## SERVICE BULLETIN

**APPLICABILITY:** 2015-2017MY Legacy and Outback

**NUMBER:** 09-66-16

**SUBJECT:** Rear Muffler Shell Rigidity Enhancement

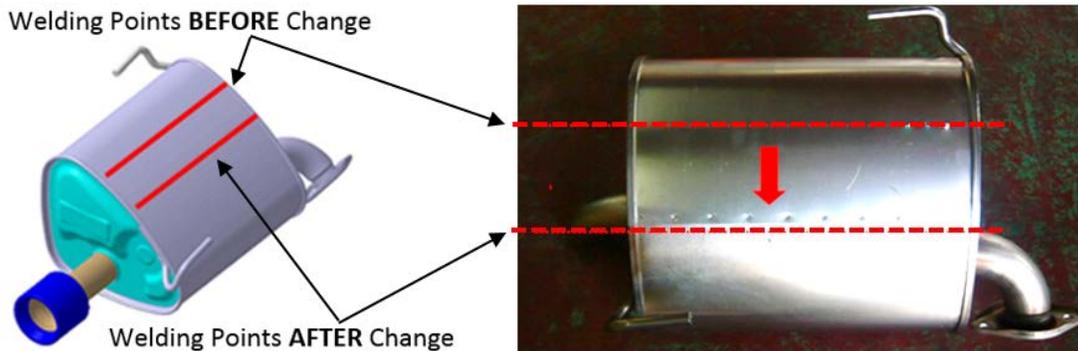
This bulletin announces a change in the production procedure for the rear muffler assembly. Spot-weld locations securing the outer shell portion have been changed to improve overall rigidity. A gap may develop at the spot welded seam as a result of repeated thermal shock (heating / cooling) which occurs during normal use. The gap does **not** create an exhaust leak. In some cases, a rattling sound from the muffler may develop.

The line of spot-welds has been repositioned approximately 2” (50 mm) as shown below.
